Subject: Piper Aircraft, Inc. Comments to the "Interim" Notice of Proposed Rulemaking AD, Docket No. FAA-2018-1046; Product Identifier 2018-CE-049-AD

Figure 1: Location Inspection Area

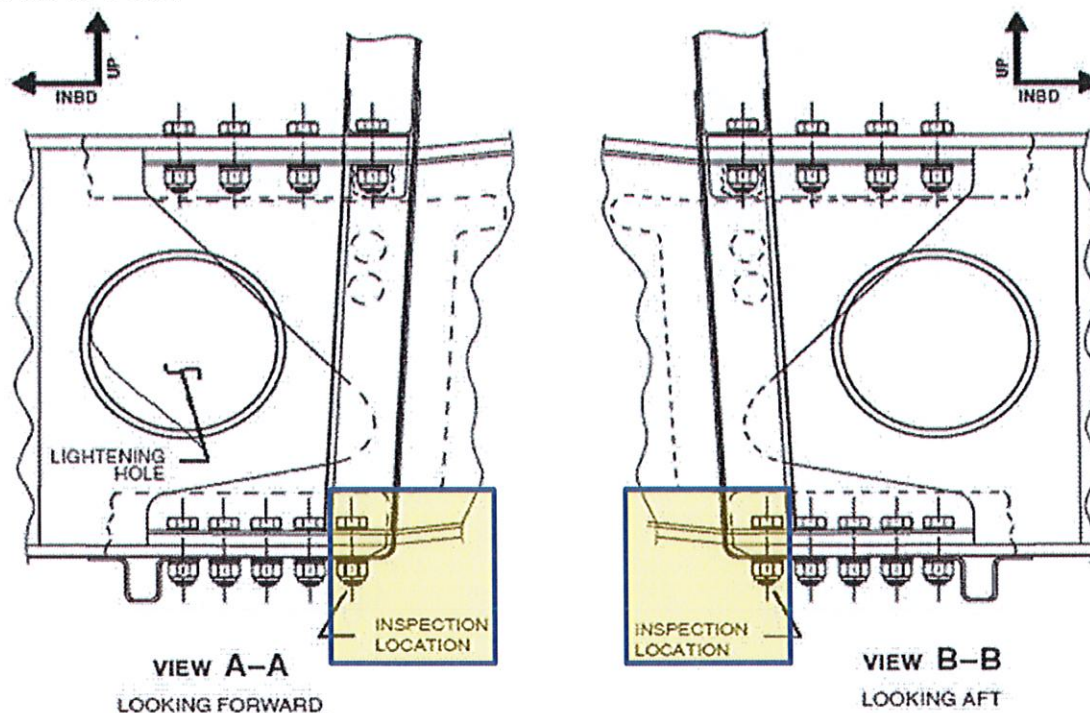
The tasks required in order to perform the fastener removal for the inspection pose additional unnecessary risks which may create a feature (notch, gouge, thread mark, etc.) that is likely to cause a safety or airworthiness hazard. The hazard is tied to the removal of the outboard lower wing to fuselage spar attachment bolts. The directed activity is not a part of regular maintenance activities and requires the mechanic to maneuver in the confined area around the wing spar in order to gain access to both sides of the proposed inspection bolts and associated holes as shown below in the figure taken from the NPRM AD's text:

Unnecessarily removing the wings or wing attachment fasteners on this large quantity of aircraft causes a high potential for unintended damage which will then lead to a new safety concern for the FAA, Piper and our common constituents; the tens of thousands of owner operators flying these proven aircraft designs. As this damage would create a continued operational safety issue, it is imperative that the model series be reduced by limiting the scope of inspections to a smaller more relevant representative group. Additionally, the action may potentially render the wing spar or its fuselage attachments un-airworthy or at a minimum require a repair with an associated FAA approved AMOC as the FAA references in the text of the "Interim" NPRM AD proposal with no alternative solution or standard repair method provided other than wing disassembly and spar replacement.
